**ARCHITECTURAL REVIEW FINDINGS AND  
DECISION**  
**\*\* APPROVAL WITH CONDITIONS \*\***

Case #: AR-15-02  
Project: Barker Cabinets Building Addition  
Location: [19355 SW 125th Ct](#) (Tax Lot 2S1 21DA 00600)  
Applicant: AJ Michaud, TS Gray Construction (503-692-4675) (TS Gray Job 1412)

T1.0

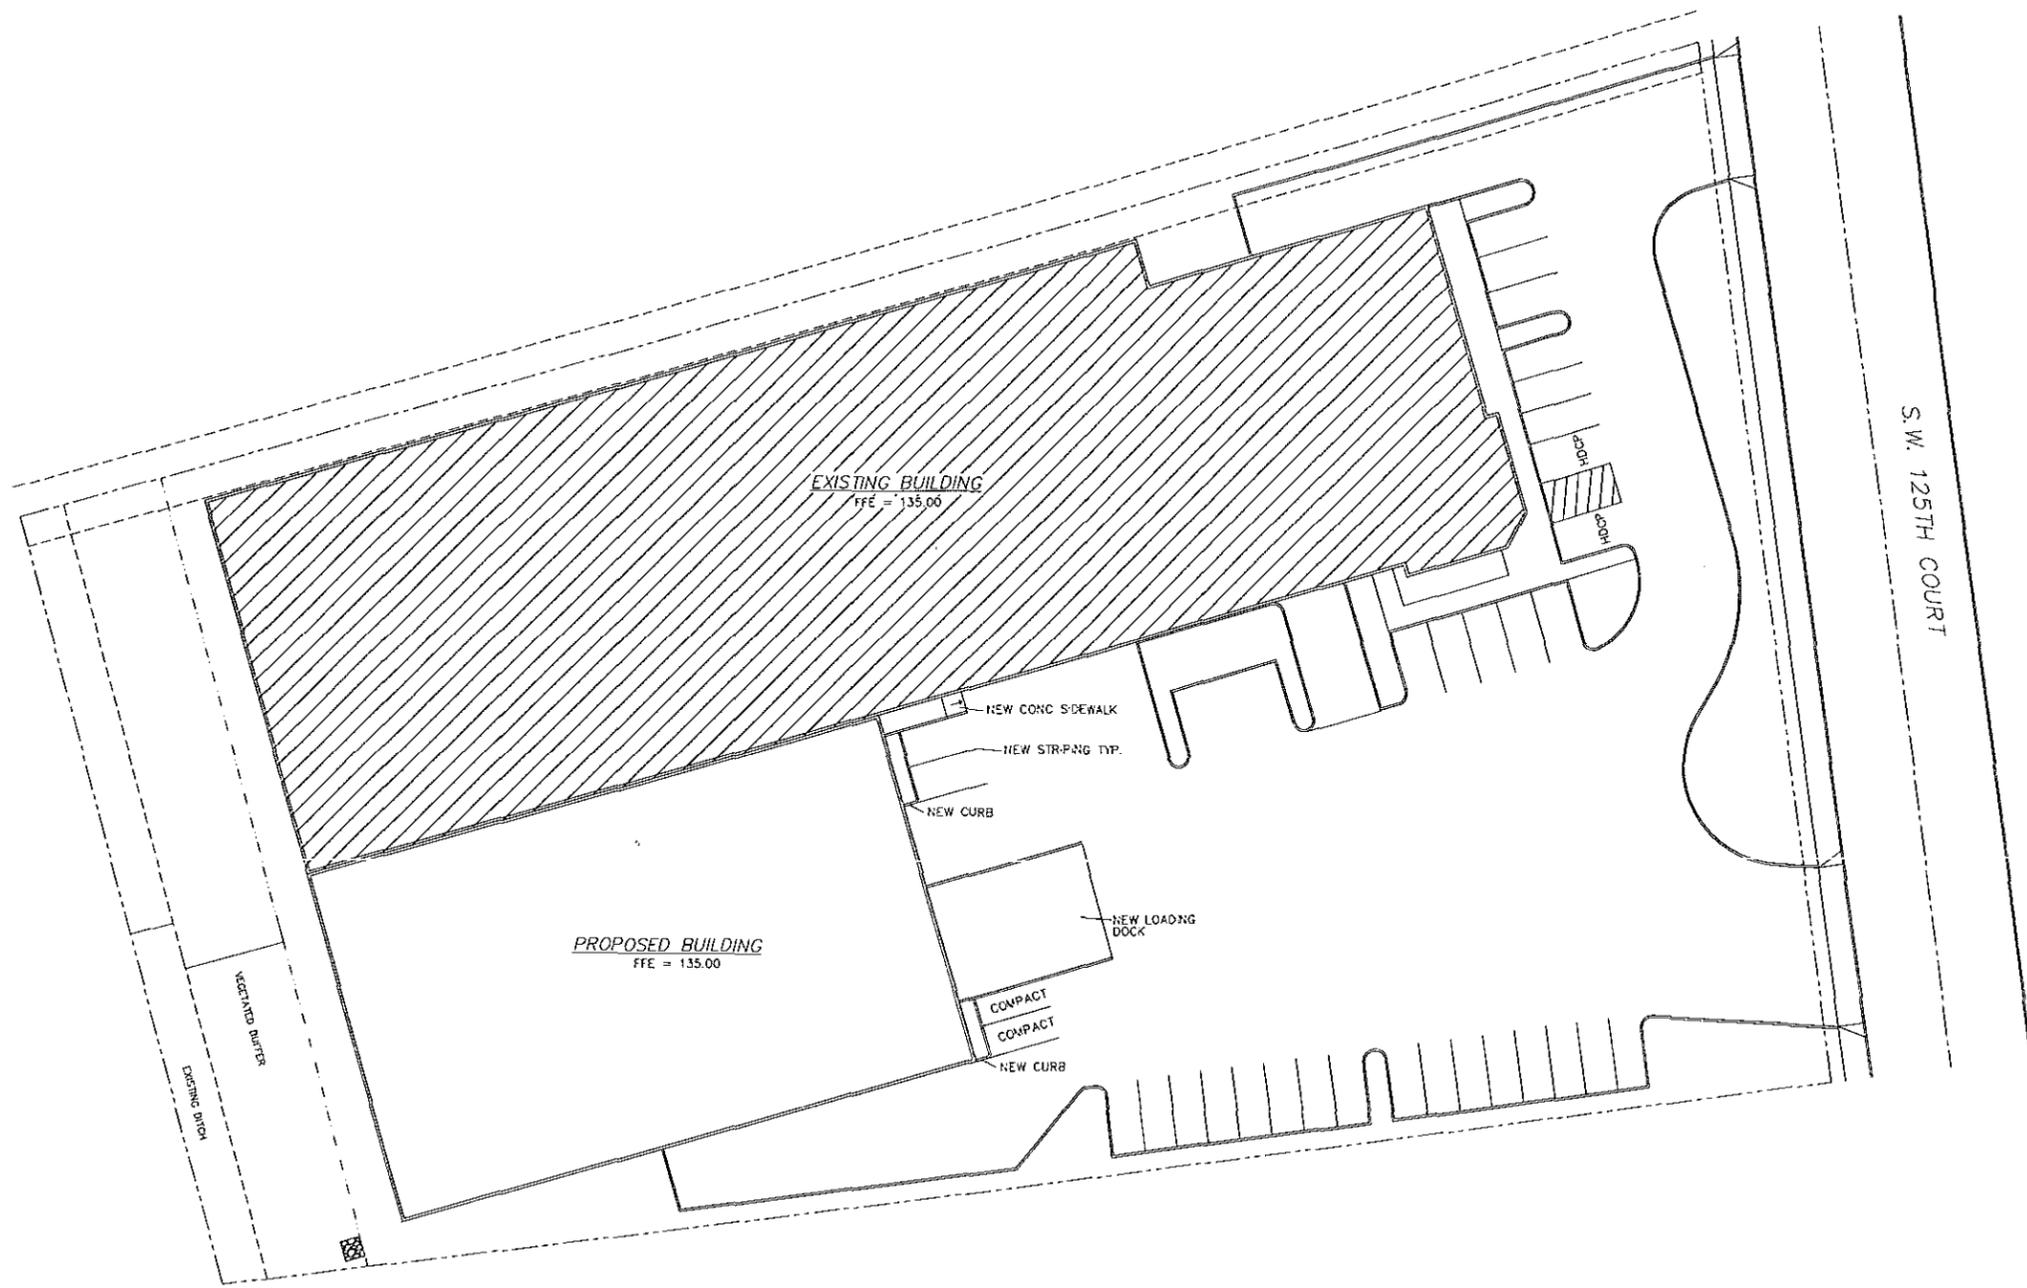
Because neither the cover nor landscape plan sheet notes the landscaping area, staff is unable to determine compliance and so is applying a condition.

SHEET  
**A1.0**

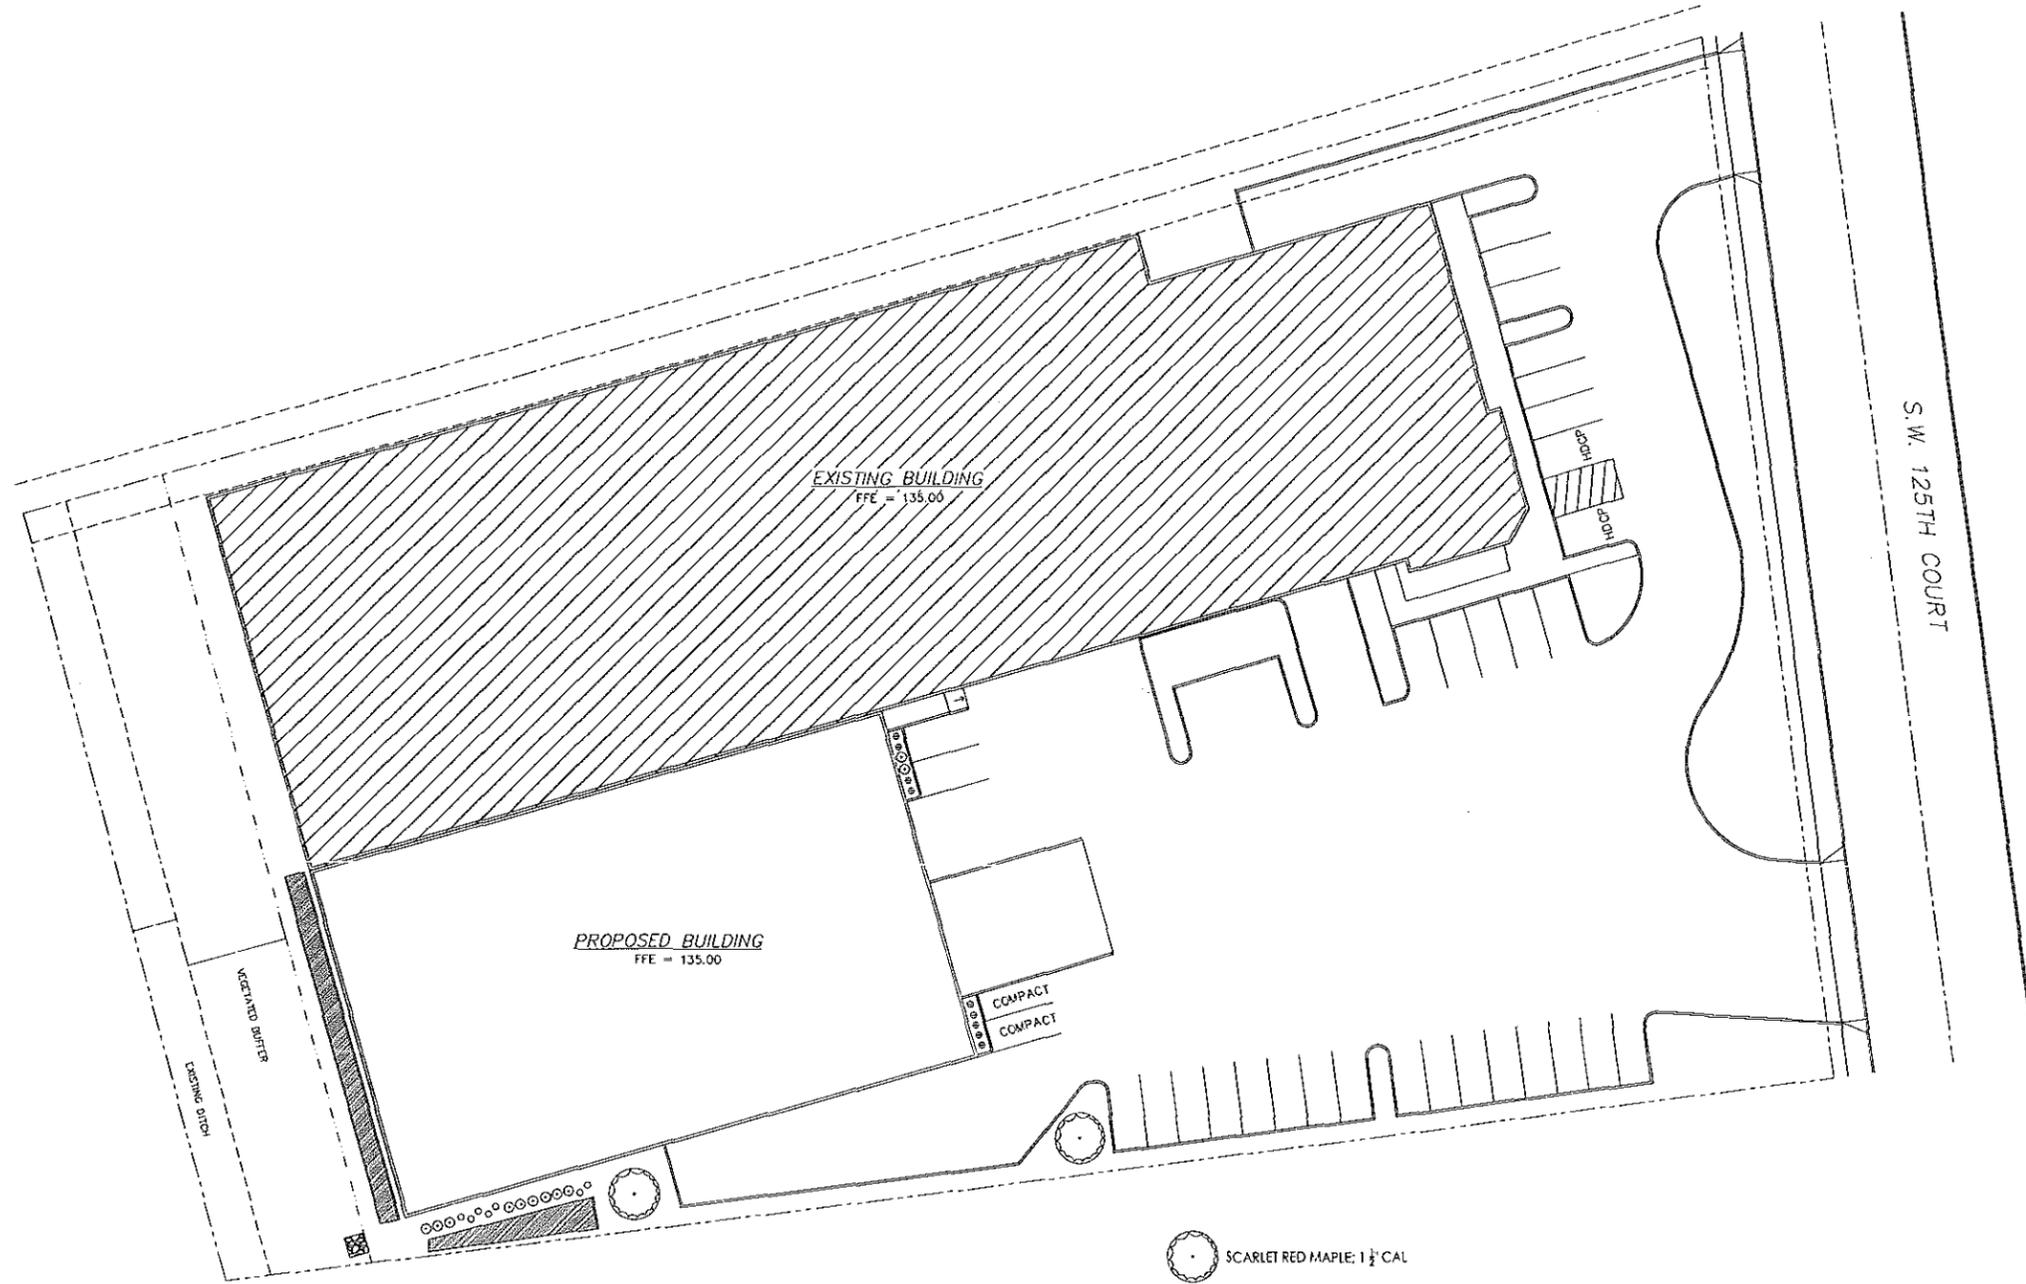
- The applicant shall revise the site plans as necessary to show consistently either all intended at grade and rooftop electrical and mechanical equipment and its screening, or, note that there will be no such equipment in need of screening.

- The applicant shall revise the landscape plan to note the total parking area landscaping square footage and illustrate parking area deciduous trees.

- The applicant shall revise the site plans to indicate and provide two (2) C/V spaces at Building 3, preferably near an entrance or entrances most convenient for employees.

- The applicant shall revise the site plans to note and provide signage, be it freestanding signs and/or pavement striping of “CARPOOL VANPOOL” or similar.

Though the site plans proposes no on and above grade electrical and mechanical equipment, the applicant or successor might intend or later propose such equipment. For this reason, staff is applying a condition. The applicant needs to revise the site plans as necessary to note or show all intended at grade and rooftop electrical and mechanical equipment and its screening.

Because the site plans lack illustration or notation of an existing or extended automatic irrigation system, staff is unable to determine compliance and so is applying a condition.

The proposal includes a partially reconfigured parking lot, and none of the cover, site, or landscape plan sheets indicates the landscaping square footage related to the requirement of (1) and number of deciduous trees related to the requirement of (3). For these reasons, staff is applying a condition.

AR-95-54 approved two carpool/vanpool (C/V) spaces among the group of five spaces south of the main entrance at the southeast corner of the building. The present AR-15-02 site plans call out compact and handicap spaces, but not C/V spaces, leaving it unclear as to whether these spaces remain or will be retained and if the requirement is continued to be met. For this reason, staff is applying a condition. The applicant needs to revise the site plans to indicate and provide two (2) C/V spaces.

Because the site plans and other application materials lack information about C/V parking, staff cannot determine continued compliance and so is applying a condition. The applicant needs to revise the site plans to note signage, be it freestanding signs and/or pavement striping of “CARPOOL VANPOOL” or similar.

- The applicant shall revise the landscape plan to note that the landscaped area is at least fifteen (15) percent of Lot 600.

- c. To meet the requirement of 73.280, landscaped areas shall be irrigated with an automatic underground or drip irrigation system.
  - The applicant shall revise plans to illustrate or note provision of an automatic irrigation system.

- The applicant shall revise the landscape plan to note that the landscaped area is at least fifteen (15) percent of Lot 600.

- The applicant shall revise plans to illustrate or note provision of automatic irrigation.

- The applicant shall revise the landscape plan to note the total parking area landscaping square footage and illustrate parking area deciduous trees.

- The applicant shall revise the site plans to indicate and provide two (2) C/V spaces.

- The applicant shall revise the site plans to note and provide signage, be it freestanding signs and/or pavement striping of “CARPOOL VANPOOL” or similar.
